## DEVIATION REQUEST AND DECISION FORM

VR233

Project Name : Claremont Business Park 2 Filing No. 2

# V1\_Deviation Request Radius Redlines.pdf Markup Summary

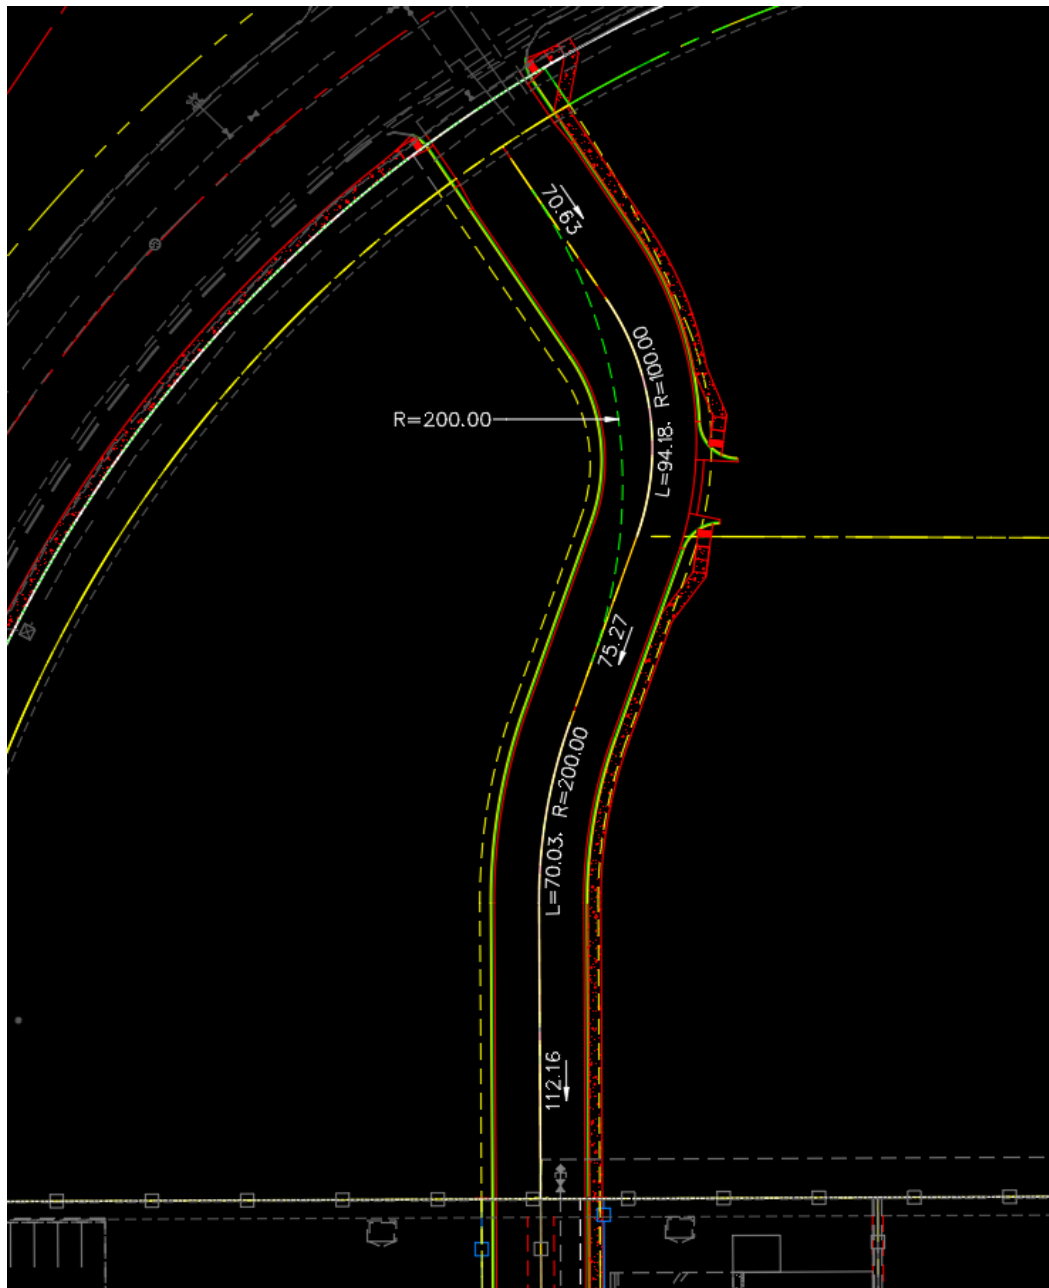
- We request approval of a 100' minimum centerline radius, whereas the radius requirement is 200' at (1) one (north curve) curvilinear location within the El Jefe Heights roadway. Meeting the 200' radius requirement would inhibit adequate distance between the two proposed curves. See the image below of the proposal for the 100' vs. the 200' radius requirement.
